# HISTORIC AND DESIGN REVIEW COMMISSION

**HDRC CASE NO:** 2022-414  
**ADDRESS:** 300 ALAMO PLAZA  
**LEGAL DESCRIPTION:** NCB 115 BLK LOT ALL OF BLK & P-100(.209AC)  
**ZONING:** D, H, RIO-3, Public Property  
**CITY COUNCIL DIST.:** 1  
**DISTRICT:** Alamo Plaza Historic District  
**LANDMARK:** Individual Landmark  
**APPLICANT:** Kate Rogers, Alamo Trust, Inc.  
**OWNER:** City of San Antonio  
**TYPE OF WORK:** Construction of the Mission Gate and Lunette  
**APPLICATION RECEIVED:** August 01, 2022  
**60-DAY REVIEW:** Not applicable due to City Council Emergency Orders  
**CASE MANAGER:** Edward Hall

The applicant, Alamo Trust, Inc., is requesting a Certificate of Appropriateness for approval to construct an interpretation of the Mission Gate and Lunette in Alamo Plaza as part of the Alamo Plan, and in partnership with the Texas General Land Office and City of San Antonio. The Lunette is proposed as a temporary installation.

**Historic and Design Review Commission**  
***Design Review Committee Report***

## MISSION GATE - PLAN

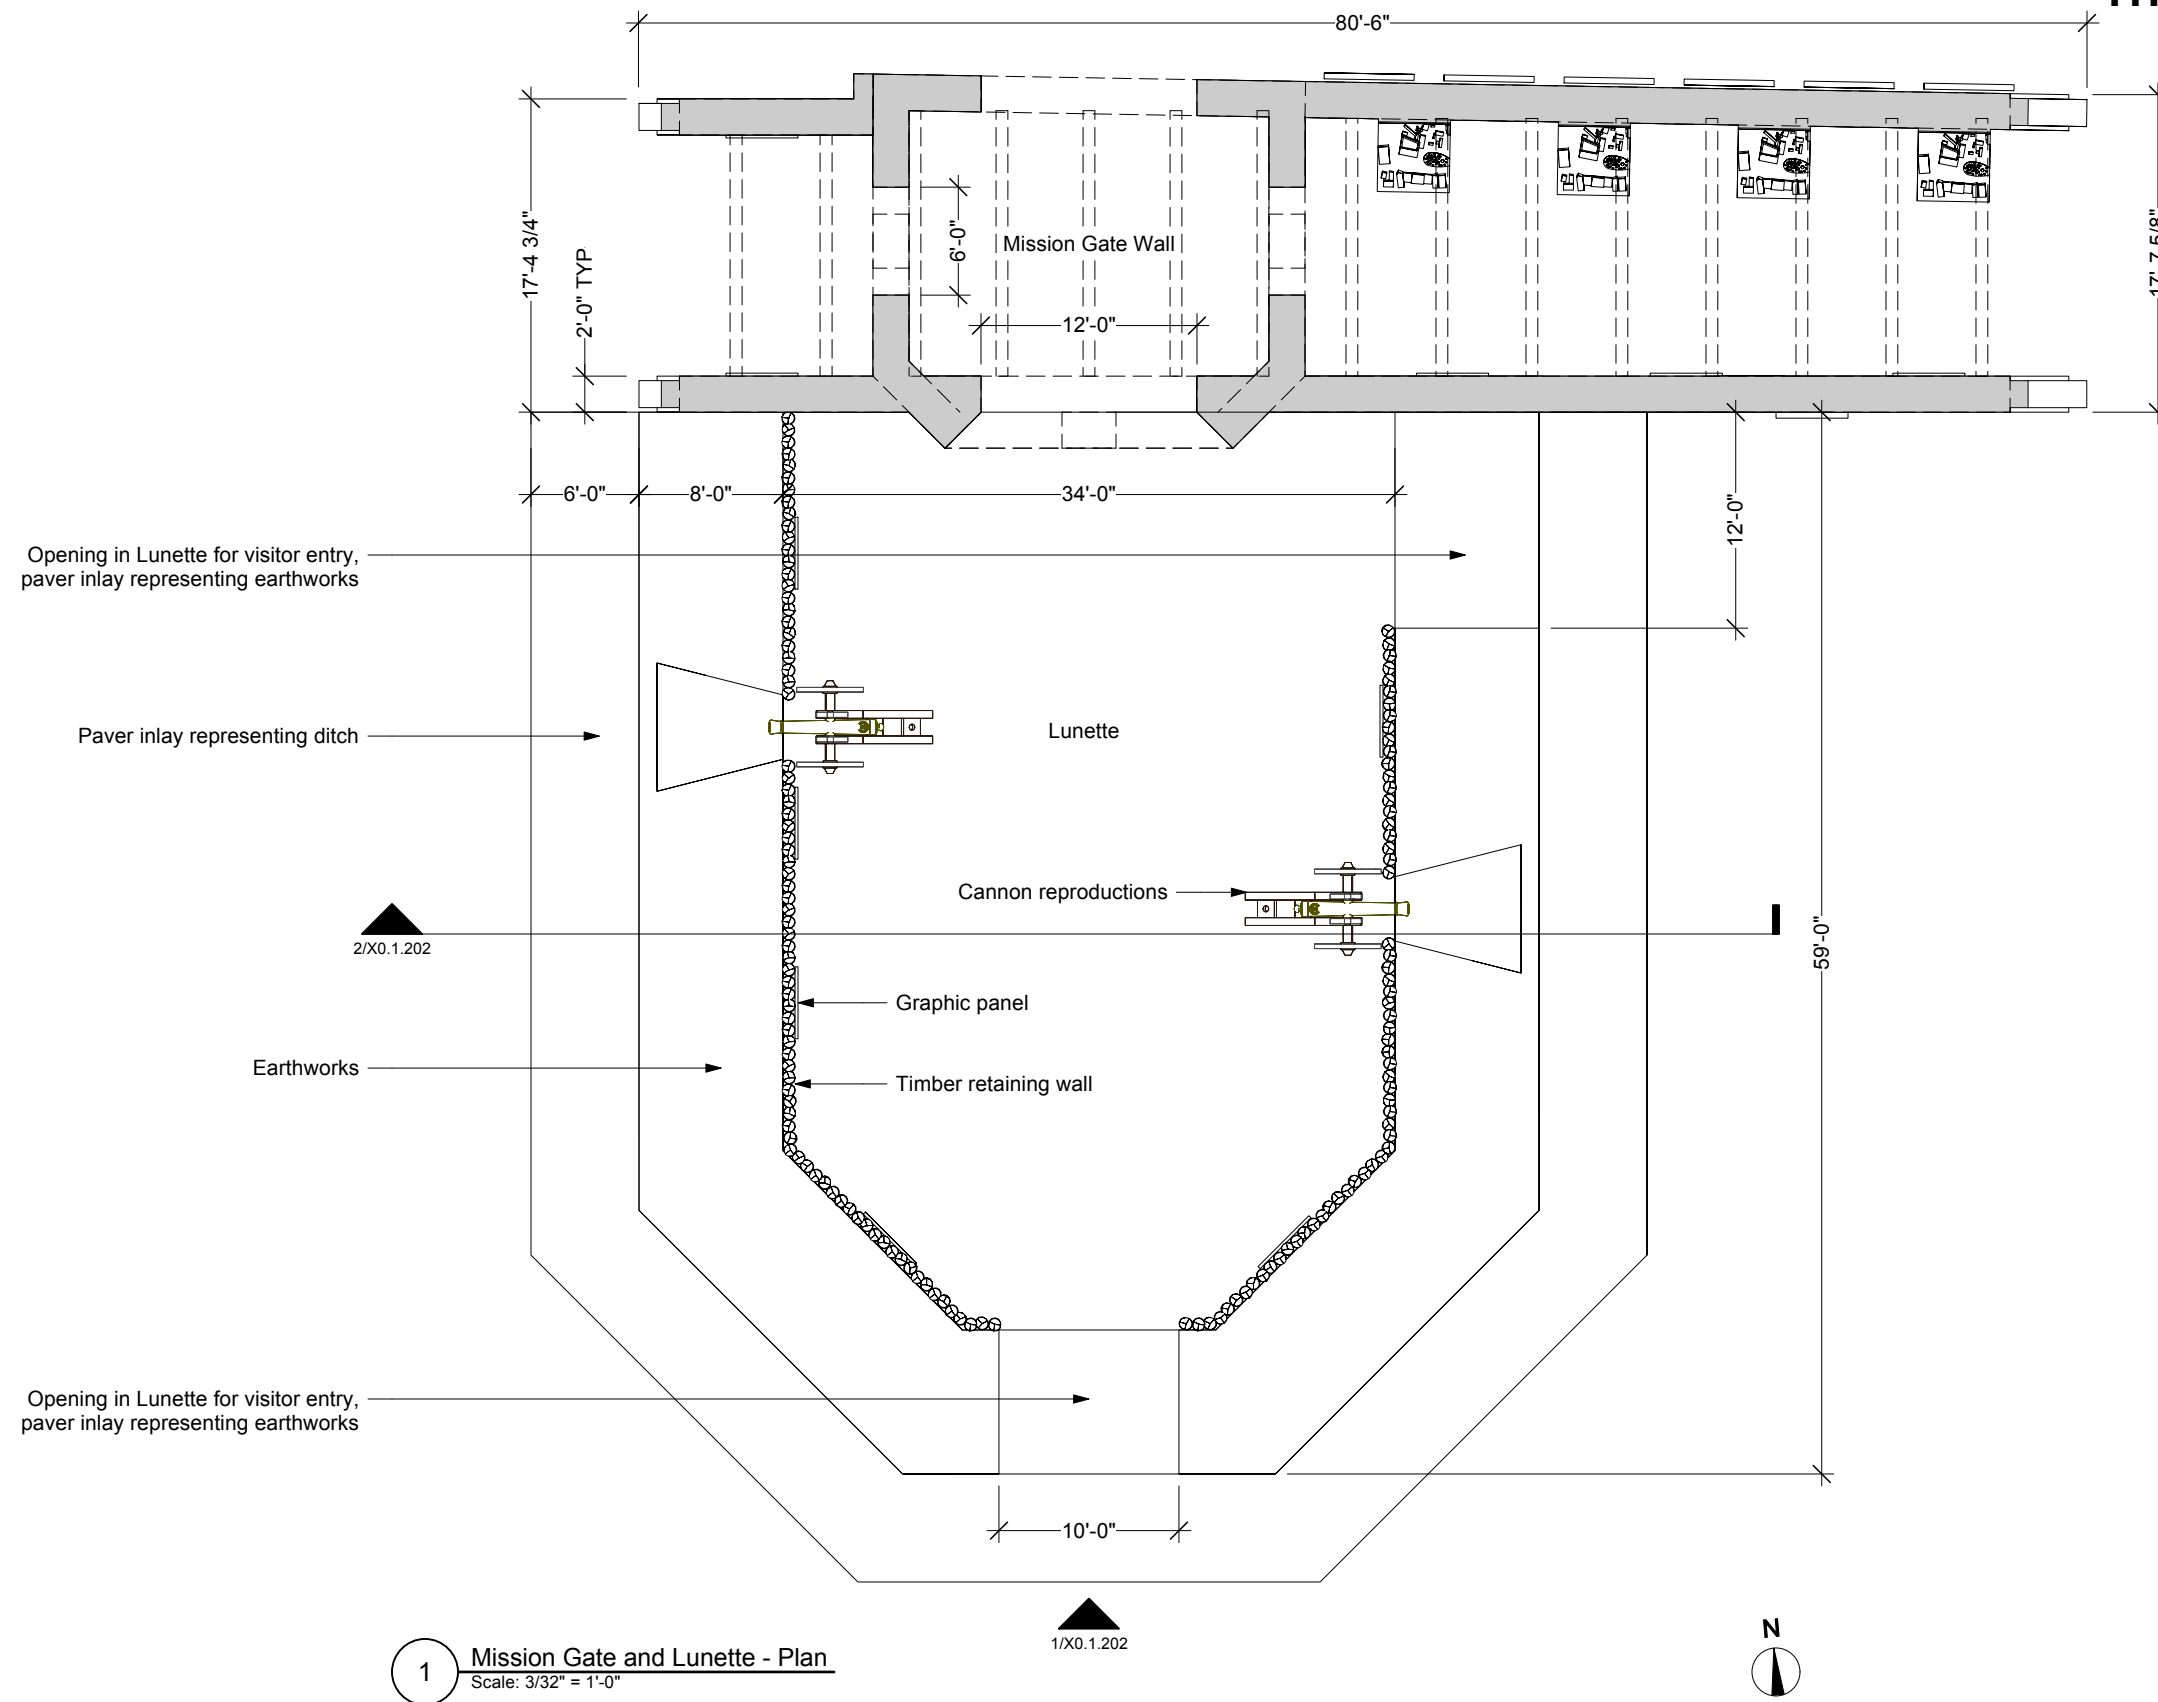
JF: Representation, not a recreation. What is the thought behind creating a faux structure, using stone and creating a somewhat “destroyed” look on each side of the gate. Why not use new materials for a contemporary interpretation?

SC: If the gate/building on either side of the gate is represented as a faux ruin, it gives concern.

JMG: Can more photos or representation of accurate depictions be provided?

CF: Will the walls be constructed of stone?

JC – would want to understand the original height and scale of the lunette. PG – will be included in interpretation.

SC – appreciates that previous comments were included regarding treatment of exterior materials and providing a break between gate structure and lunette. Suggests showing something in ground plane. PG – will be included as pavement change at that location.

PG: The representation of the lunette is a contemporary interpretation as the original was earthwork. Some of the character of what is on site will need to be included; a mix of contemporary and recreation is needed. The appropriate balance needs to be found.

PG: The footprint is 100% accurate. The height is a general guess due to lack of dimensioned drawings. Proportionately, the taller scale did not feel correct, so the height has been reduced to give a human scale. Approximately, 20% shorter than original presumed height.

PG: Intent is a plaster finish; not a faux finish.

PG: Walls will be concrete block with plaster finish with caliche stone or another appropriate material as a finish stone.

Lunette would have been at least 16 feet tall. Exhibit proposed for 9.5 feet.
